**Re: 3238 Rodman ST NW (Square 2062, Lot 0053), 24-Z-PDRM-00057**

This letter will confirm the substance of your meeting with my staff on February 12, 2024. The purpose of this meeting was to discuss potential zoning issues for a proposed 1-story addition over the existing building footprint at the rear of the property. The property, 3238 Rodman St NW, is located in the R-2 zone.

3238 Rodman St NW  
PDRM

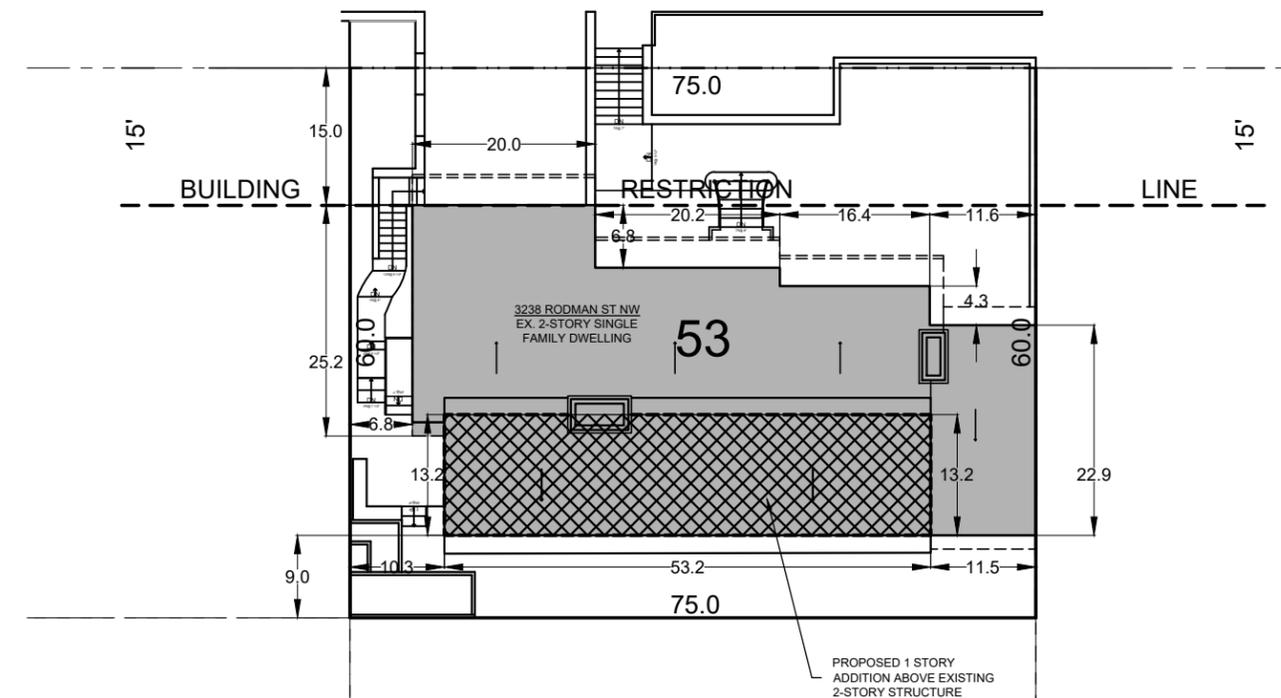
**1) Lot Occupancy: 40% allowed; 44% existing.**

You will not need a special exception for lot occupancy because the lot occupancy of the proposed addition is less than 40% and is within the existing footprint, and therefore does not extend the nonconformity. According to C-202.2:

**2) Side Yard: 8 ft required; 6.8 ft existing on west side of lot.**

You will not need a special exception for the side yard because the proposed addition is placed 10.3 ft from the lot line and is within the existing footprint, and therefore does not extend the nonconformity. According to C-202.2:

**3) Rear Yard: 20 ft required; 9 ft existing.**

You will not need a special exception for the rear yard because the proposed addition is within the existing building footprint and the home was built prior to May 12, 1958. According to D-207.3:

**4) Pervious surface: 30% required; 23% existing.**

You will not need a special exception for pervious surface because the lot occupancy is not increasing by 10% or more. According to C-501.2:

Based on this information you will be able to build this addition as a matter of right. Accordingly, when you file the plans for a building permit, my office will approve the drawings that are consistent with the information noted above.
